Serial No.:	10/027,391
Applicant:	C. Earl Woolfork
Filing Date:	12/21/2001
Group Art Unit:	2644
Examiner:	McChesney, Elizabeth A.
For:	WIRELESS DIGITAL AUDIO SYSTEM

10)☒ The drawing(s) filed on *26 August 2003* is/are: a)☐ accepted or b)☒ objected to by the Examiner.

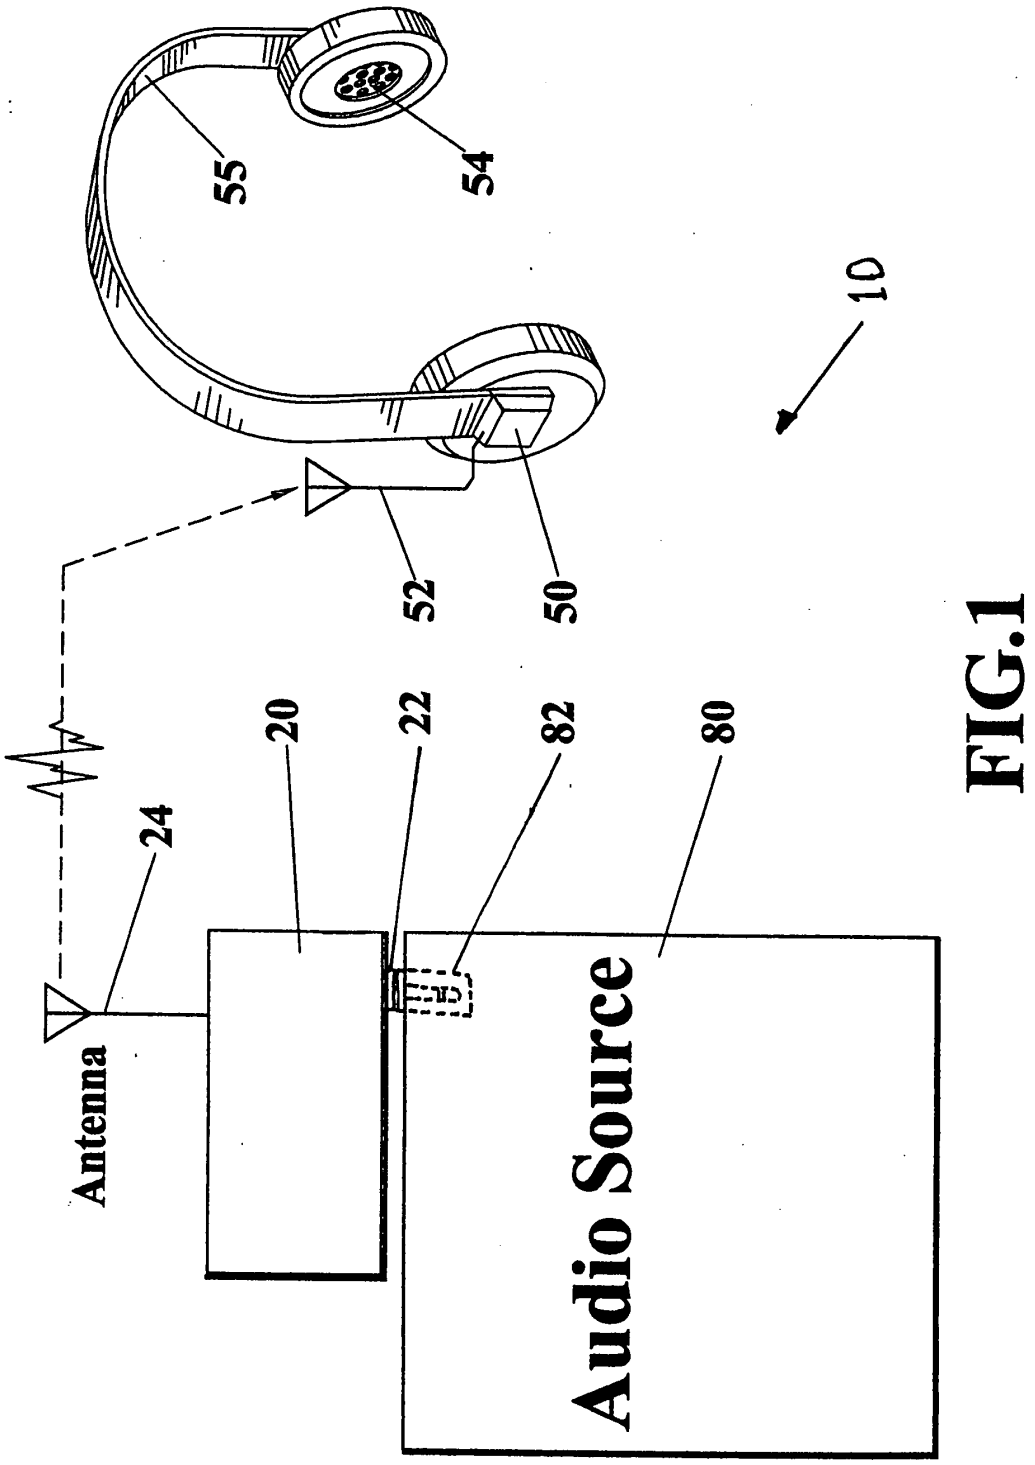
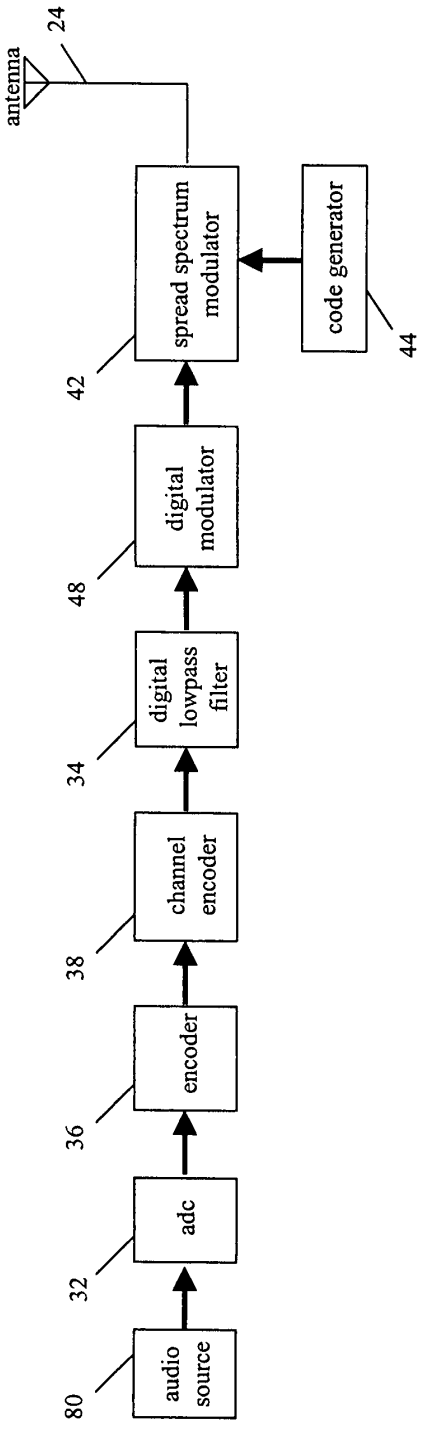
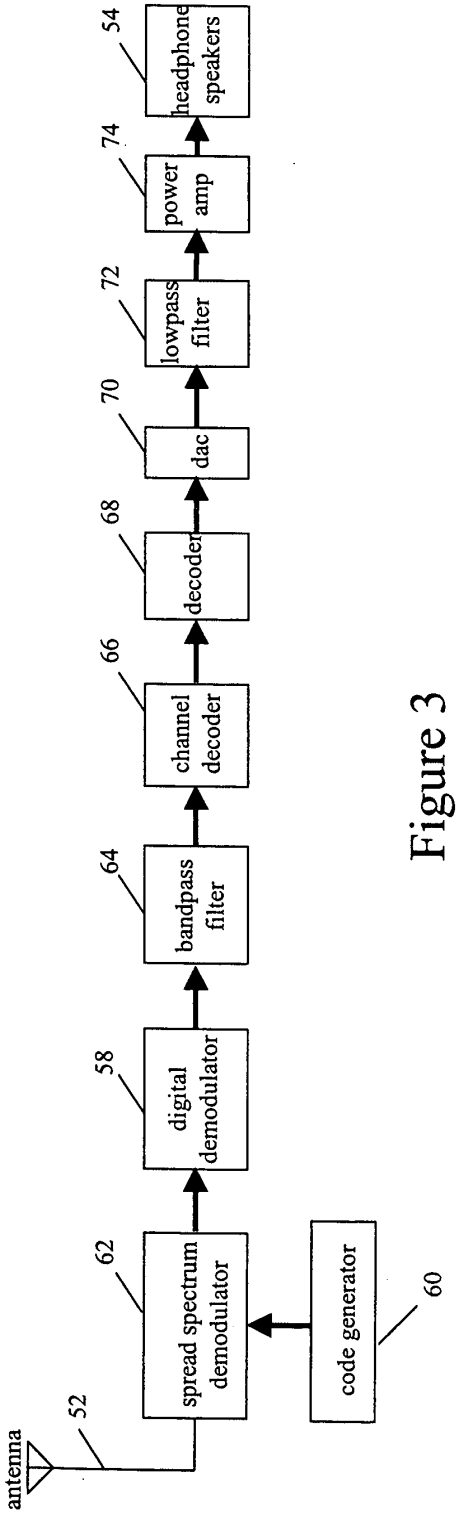
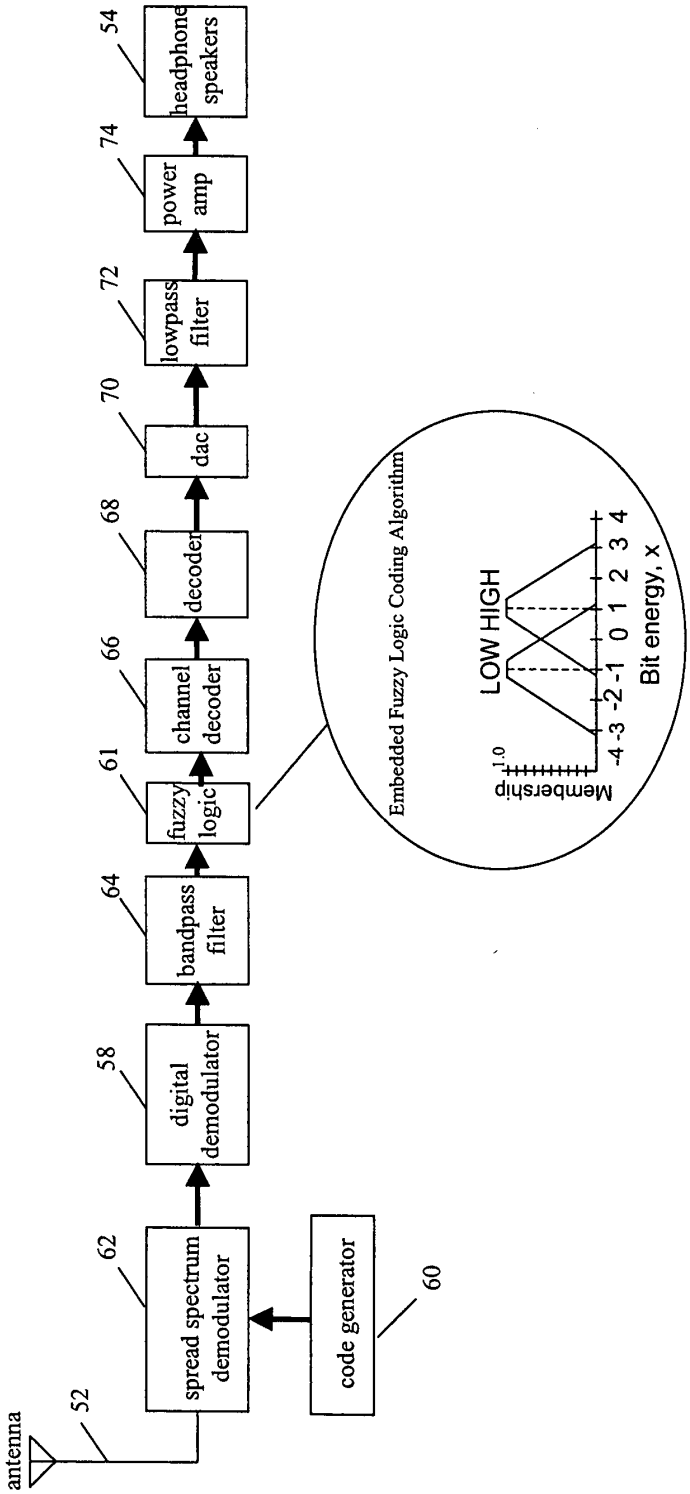
3. The drawings are objected to under 37 CFR 1.83(a). The drawings must show every feature of the invention specified in the claims. Therefore, each of the components recited in the claims, such as the codec, Bluetooth front end, shift register generator, encoder, decoder, modulator, demodulator, decoder, fuzzy logic system, as well as the steps of the methods, such as the receiving of a BLUETOOTH compliant packet, activating a fuzzy logic "if" rule, activating a fuzzy logic "then" rule, and performing a defuzzifying operation must be shown in the drawing or the feature(s) canceled from the claim(s). No new matter should be entered.

The attached sheets of drawings include corrections made to original Figures 1 and 2, the renumber of Figure 2 to Figure 4, and the addition of Figures 2 and 3 based on the examiner's comments. These sheets replace original sheets 1 and 2.

Figure 2

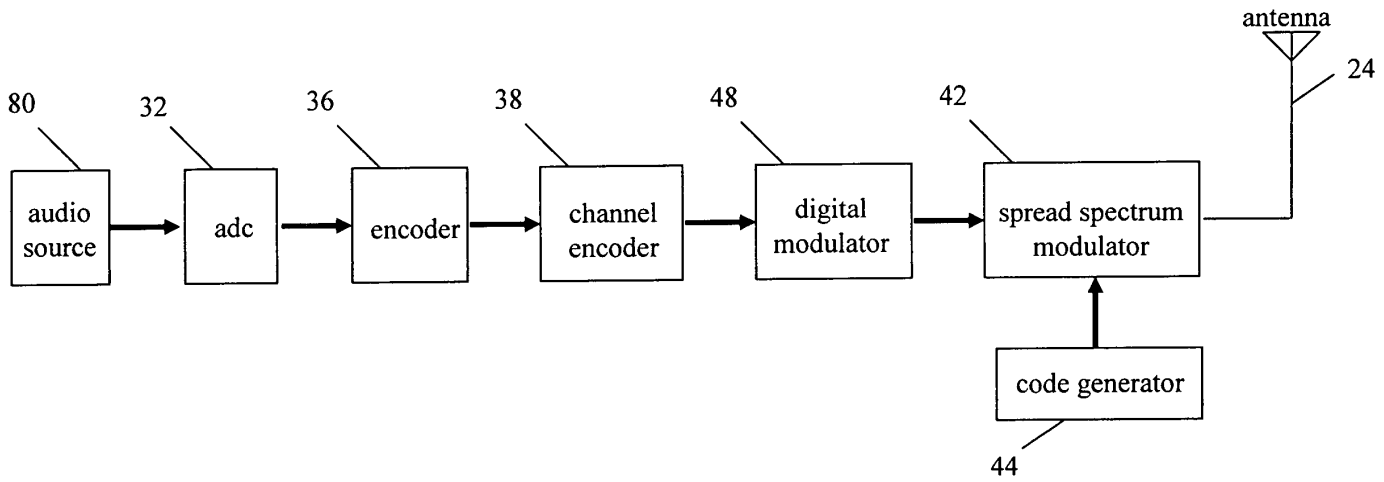
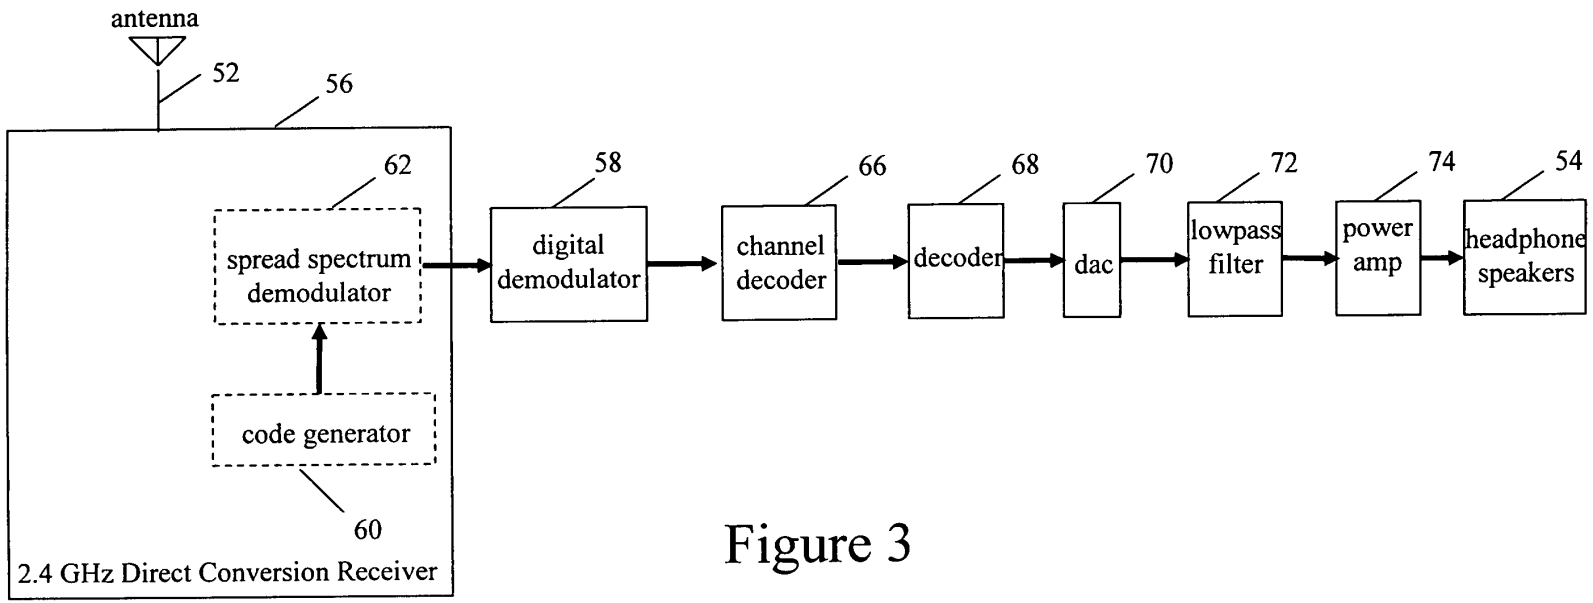
3. New corrected drawings in compliance with 37 CFR 1.121(d) are required in this application because Figures 2 and 3 incorporate new matter, which is prohibited by 37 CFR 1.121(f). The drawings of the parent application disclose the nature of the low pass filtering being "after" the D/A converter in order to correct for out of band noise caused by the D/A converter (page 3, lines 17-20). Figure 2 of the parent case shows the filter 34 between the ADC 32 and the encoder 36, which differs from the order shown in Figure 2 of the present application. New matter is incorporated by this altered shown order, as well as the inference from the drawings that a signal containing error can be effectively low pass filtered after the erroneous part of the signal has been both encoded and channel encoded. A similar basis exists for the objection to Figure 3. The bandpass filter 54 is shown and described in the parent case as following the antenna 52 and the spread spectrum demodulator (62)(page 4, lines 6-25 of the parent application). New matter is incorporated by this drawing by virtue of its altered shown order, which suggests the bandpass filtering of a spread spectrum and digitally demodulated signals, which is not clearly supported by the present or parent application.

Figure 2

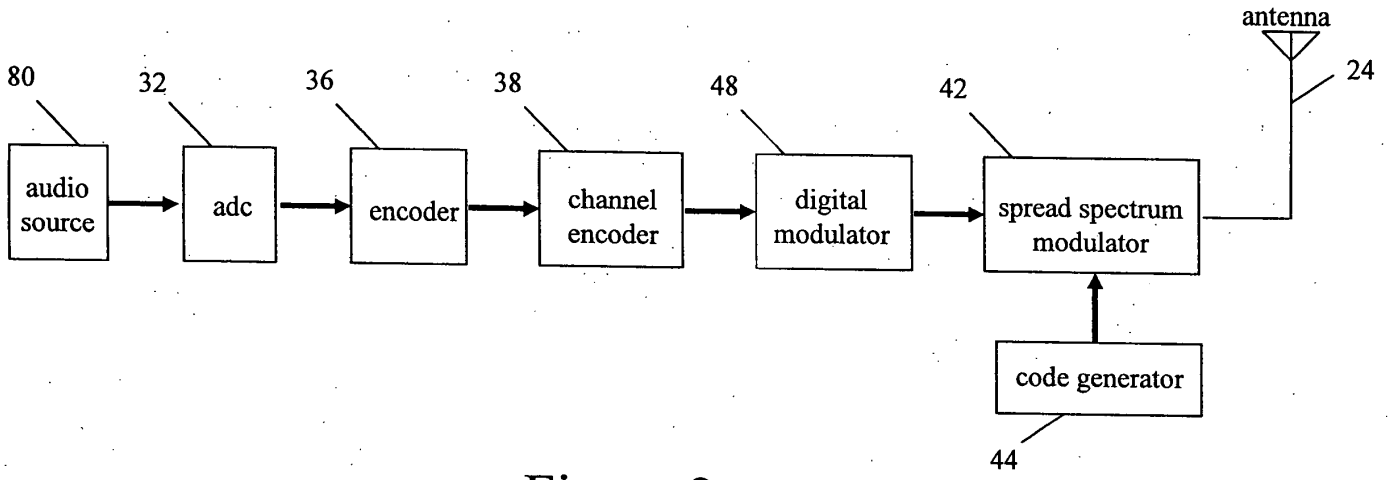
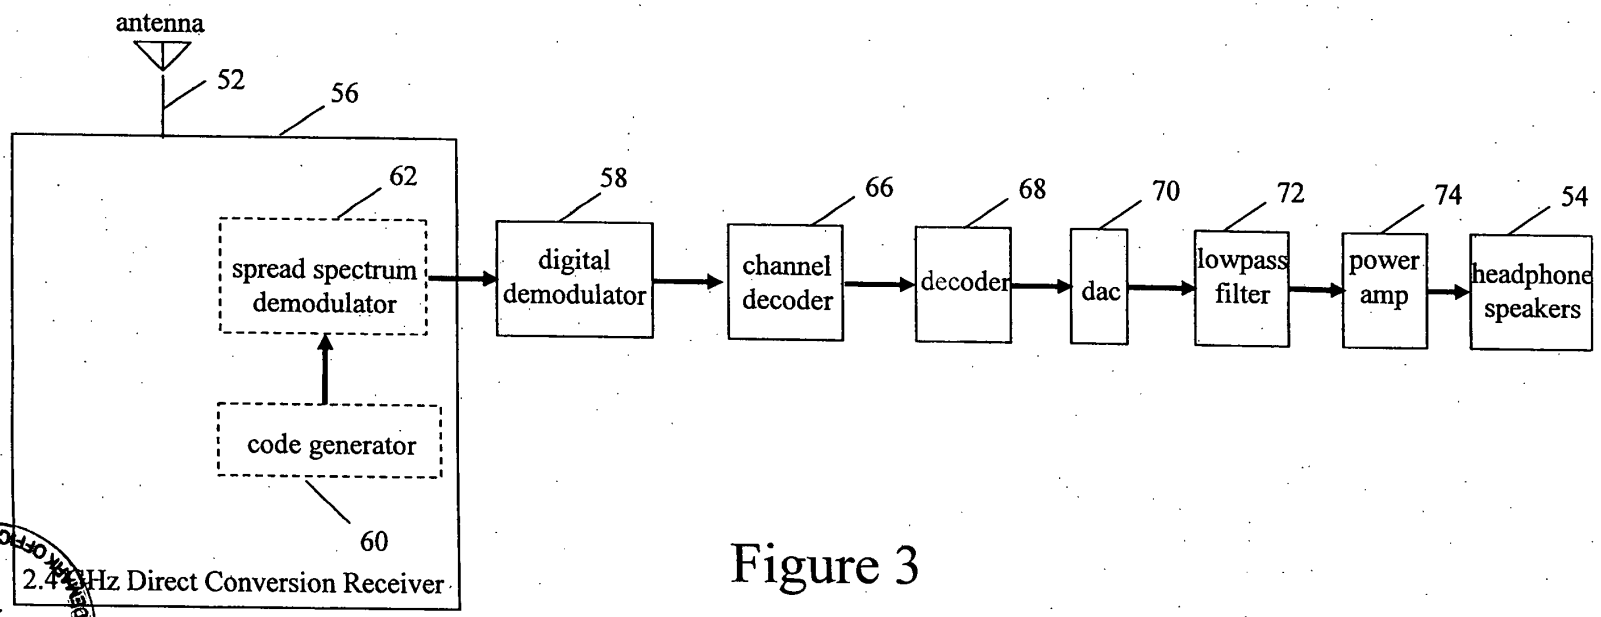
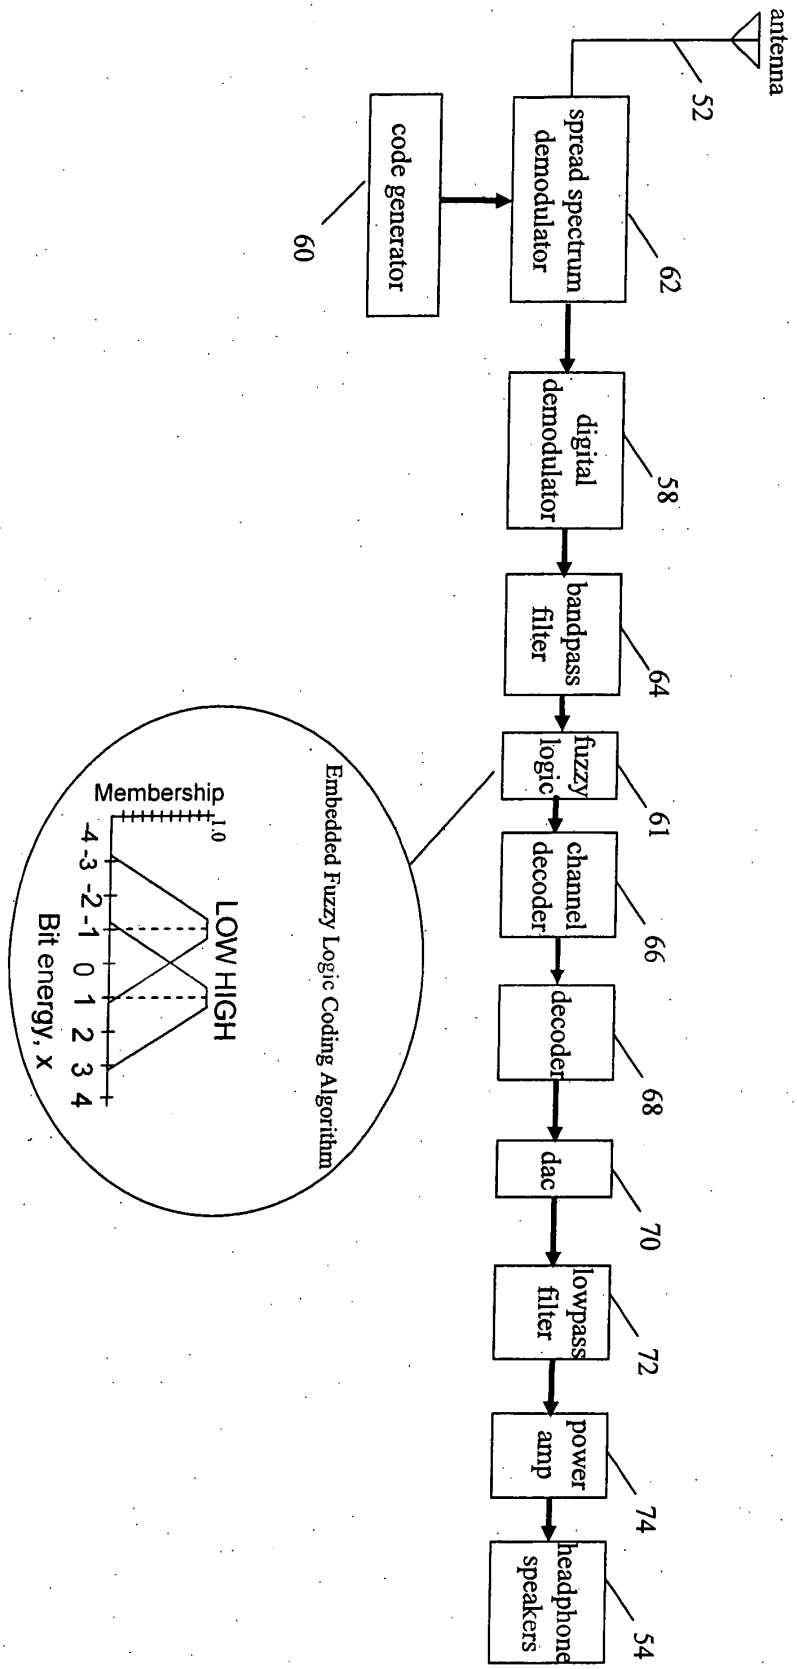
New corrected drawings in compliance with 37 CFR 1.121(d) are required in this application because Figure 2 incorporates new matter, which is prohibited by 37 CFG 1.121(f).

The drawings submitted 17 March 2006 show the code generator (60) and spread spectrum demodulator (62) integrated to form the direct conversion receiver 56. A 2.4 GHz direct conversion receiver is not previously disclosed including these two elements as shown in the present drawings and thus create a new matter situation. A direct conversion receiver (56) is shown in the parent application's drawings (Fig. 3
